SUBJECT: Calvert Cliffs Nuclear Power Plant
Unit No. 1, Docket No. 50-317
Amendment to Operating License DPR-53
Fifth Cycle License Application
Responses to NRC Staff Questions

Enclosure (Calvert Cliffs Unit 1, Cycle 5, NRC Reload Questions Response -
Answers on CESEC Model Used in S-LB Analysis) - Proprietary Copies
#000001 - 000040, 20 Non-Proprietary Copies

ENCLOSURE 1

STEAM LINE RUPTURE EVENT
MODERATOR REACTIVITY vs MODERATOR DENSITY

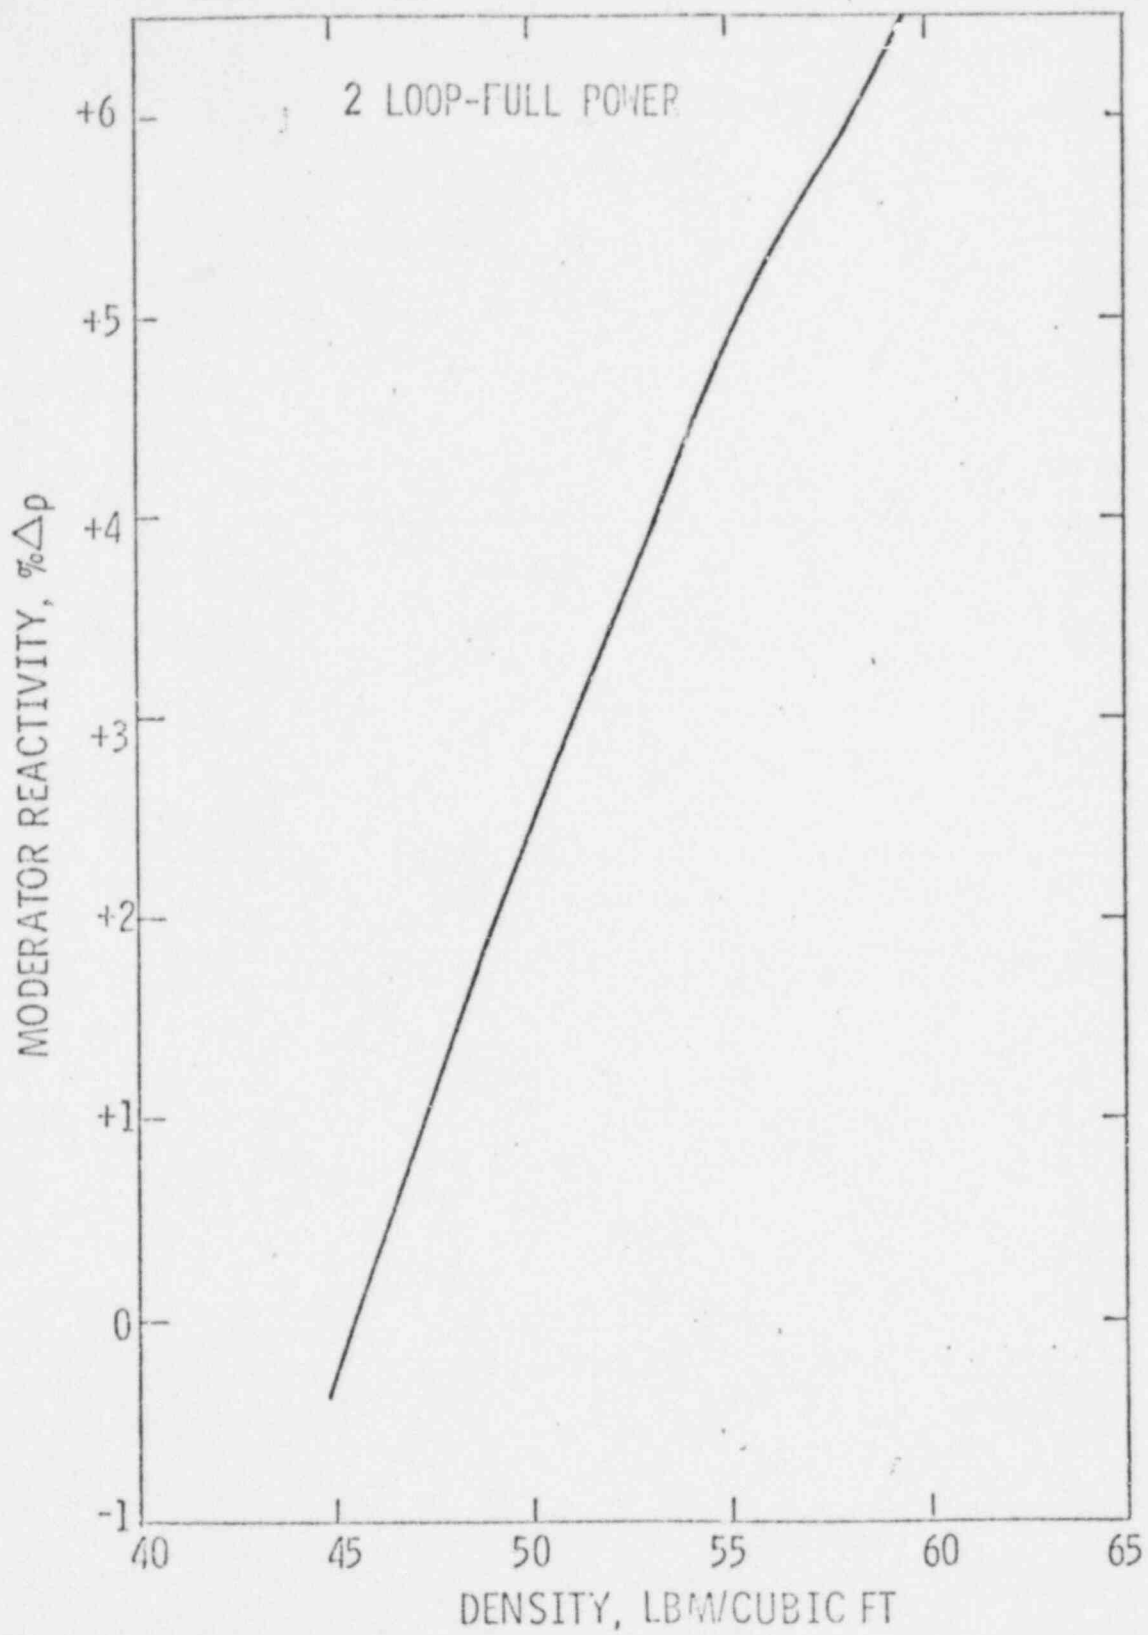
Provide a description of the overall conservatism inherent in the CESEC-SLB code. List all conservative assumptions in the codes and inputs for each parameter.

Moderator Ccool-down Curve	See Figure 1 & 2	The moderator cooldown curve corresponds to an effective MTC of $-2.2 \times 10^{-4} \Delta\alpha/^\circ\text{F}$ and is calculated assuming that a Control Element Assembly is stuck in the fully withdrawn position during the reactor scram.

SCHEMATIC DIAGRAM OF PRIMARY COOLANT NODES

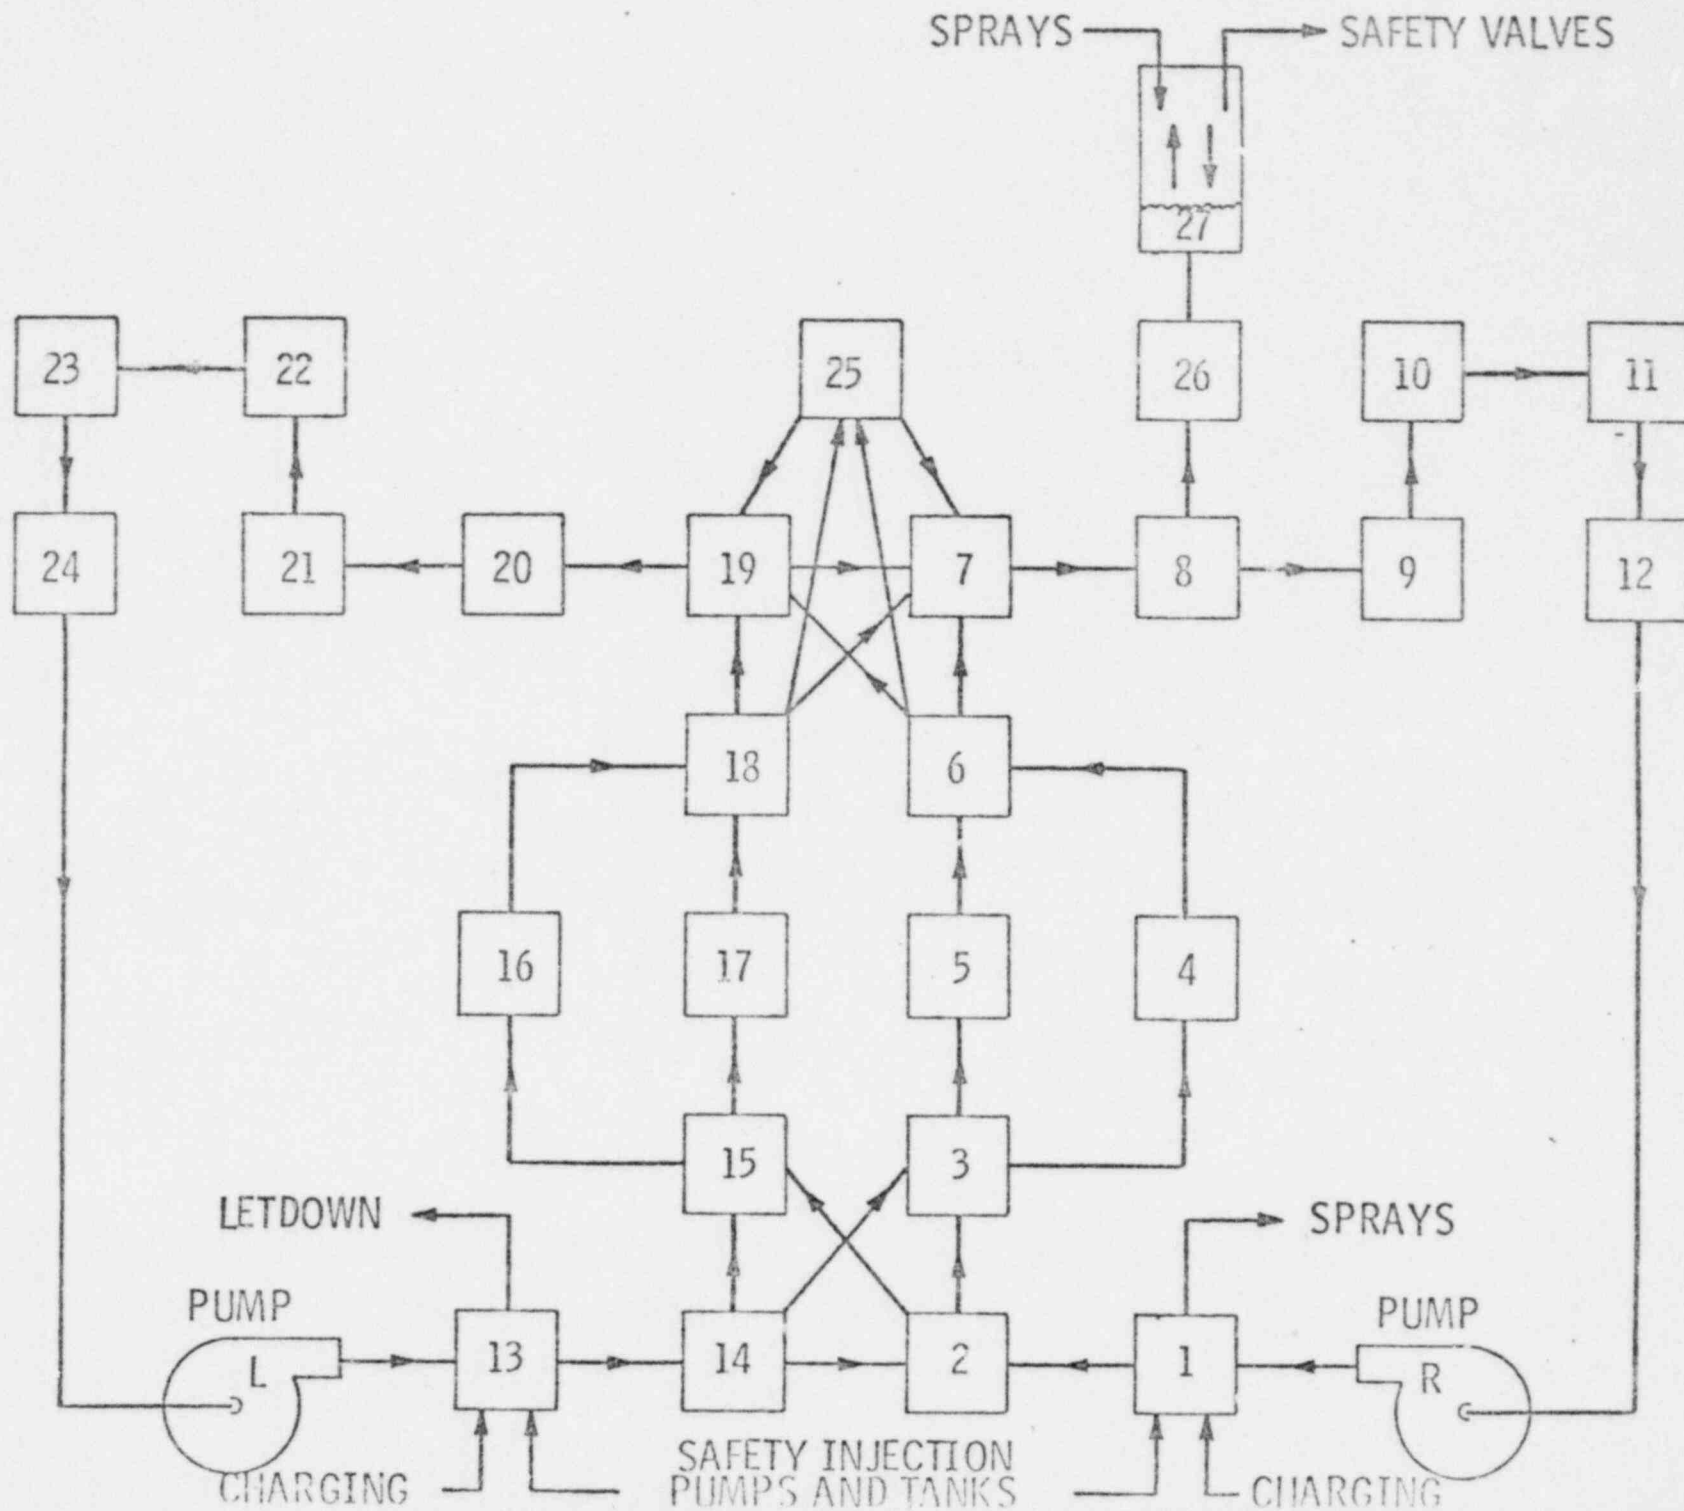
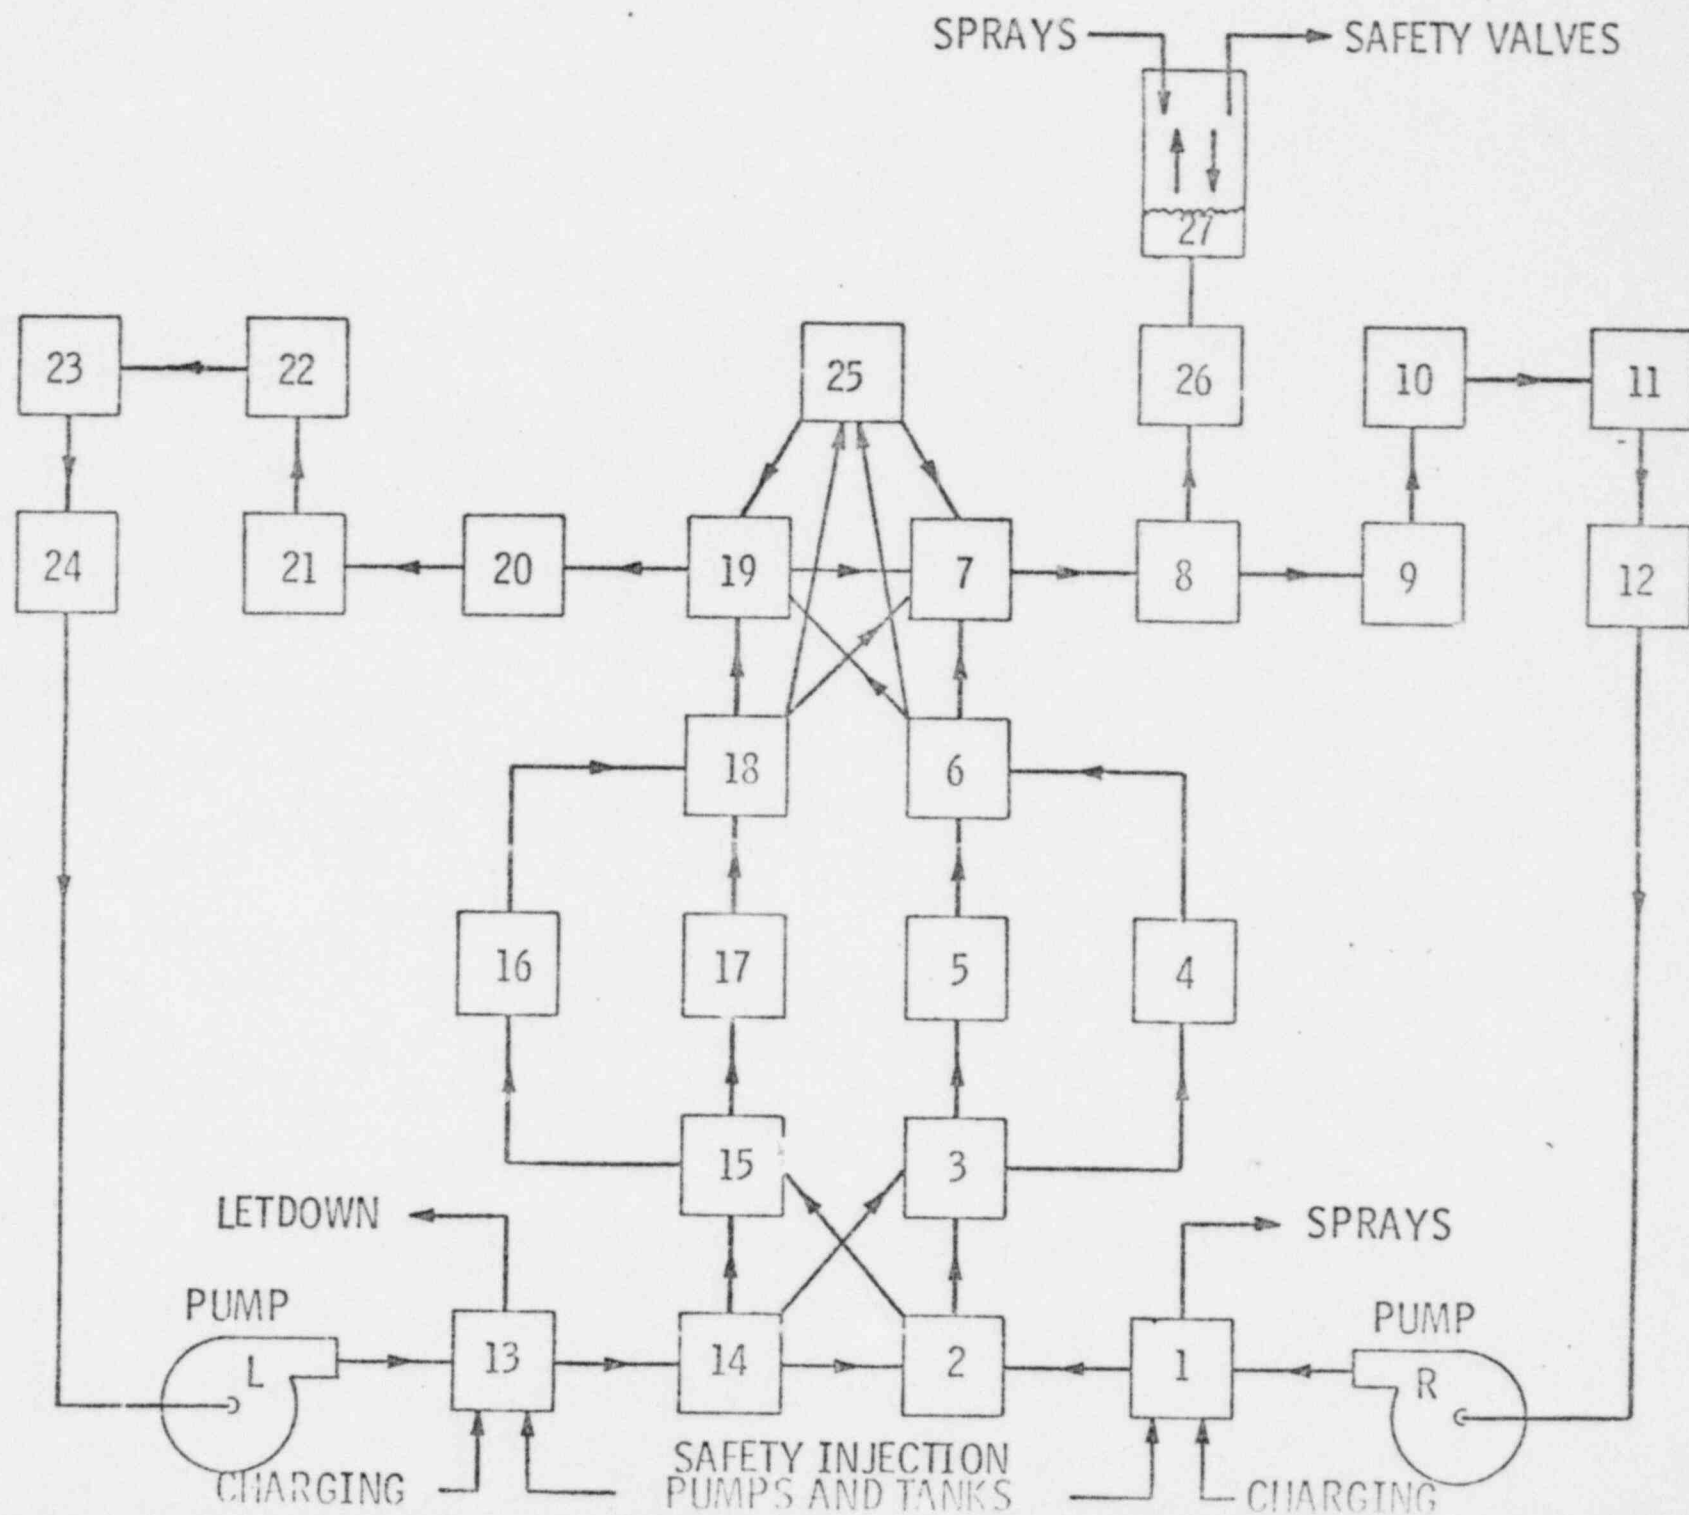
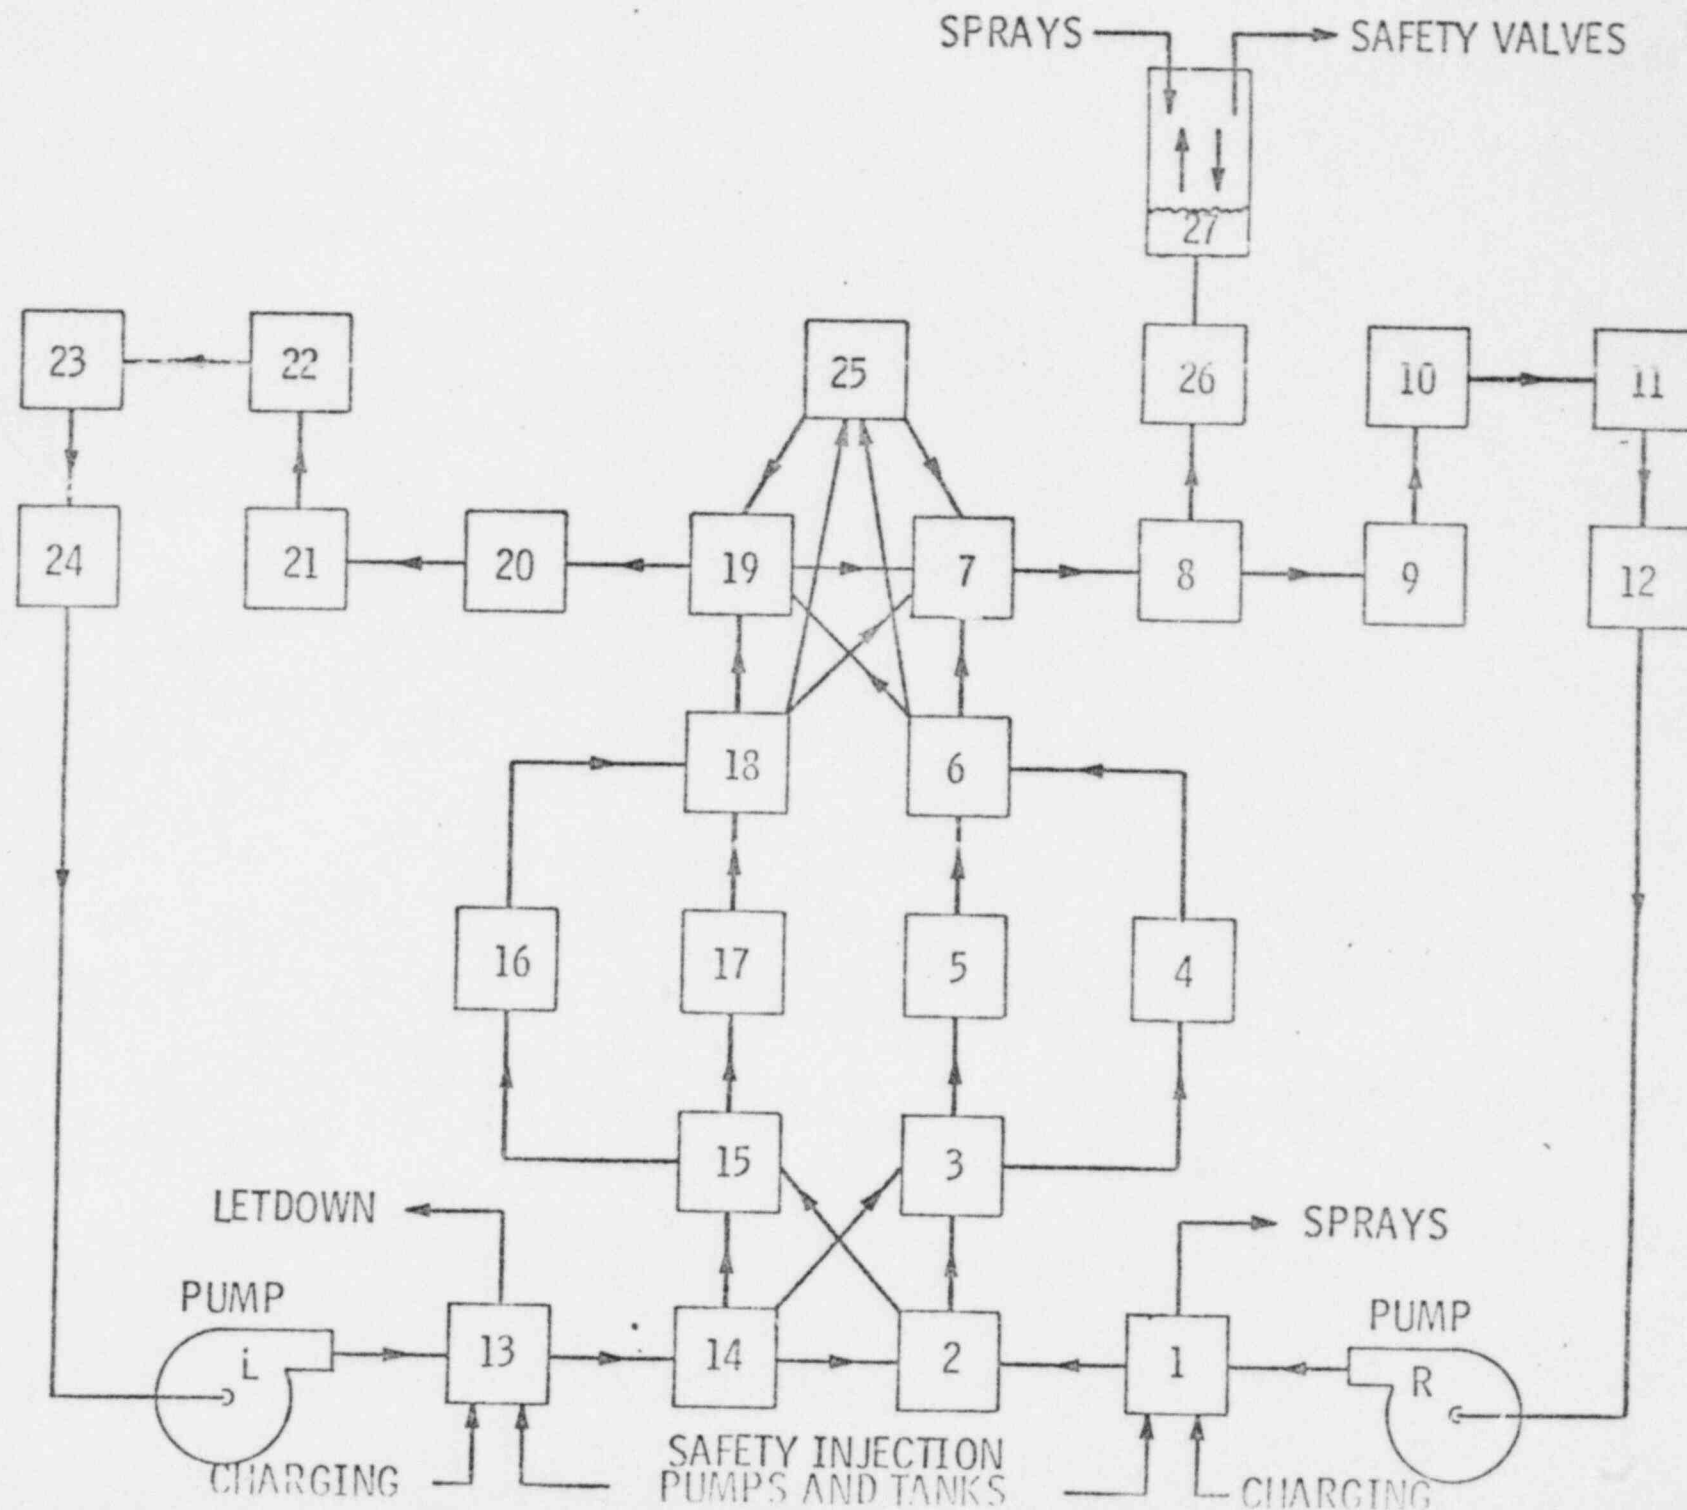
Provide a more detailed description of the code CESEC-SLB, including pertinent equations.

The Reactor Coolant System, consisting of two reactor coolant loops, the reactor vessel, the reactor vessel closure head and the pressurizer was divided into 27 nodes of constant volume for this analysis. The nodal scheme given in Figures 3A and 3B was chosen to appropriately simulate the RCS component volumes and, thus, provide an adequate description of the spatial variation of the coolant properties. As seen from Figures 3A and 3B, nodes are specified which represent one-half the reactor vessel inlet downcome section, the
